TECHNICAL INFORMATION

Date: 30.05.2022
TI: 0922
Machine type/s: HO Siamonie Smart

New grind adjusting ring

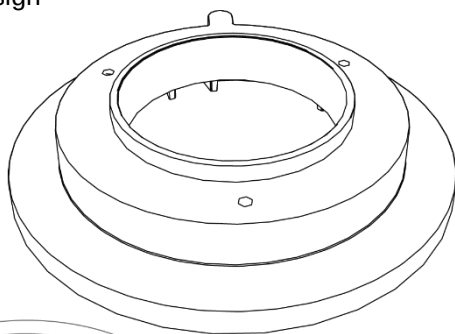
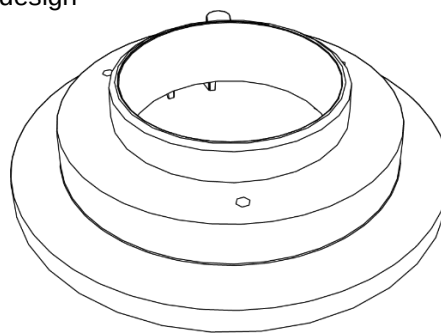
As we continually endeavour to improve our product quality we have updated the grind adjustment on our Siamonie Smart.

Thanks to this improvement the gap between grinder and bean container has been reduced even further. This is due to the flange being higher resulting in a material overlap which produces a seal. The O ring is therefore no longer required.

Grind adjusting ring
(O-ring required)

Grind adjusting ring
(no O-ring required)

The new ring for adjusting the grind will be fitted from **production week 20 2022** from **serial number 90532980** as standard.

The grind adjusting ring can still be ordered as a spare part using part number 417.00.324.00 and if necessary exchanged and upgraded.
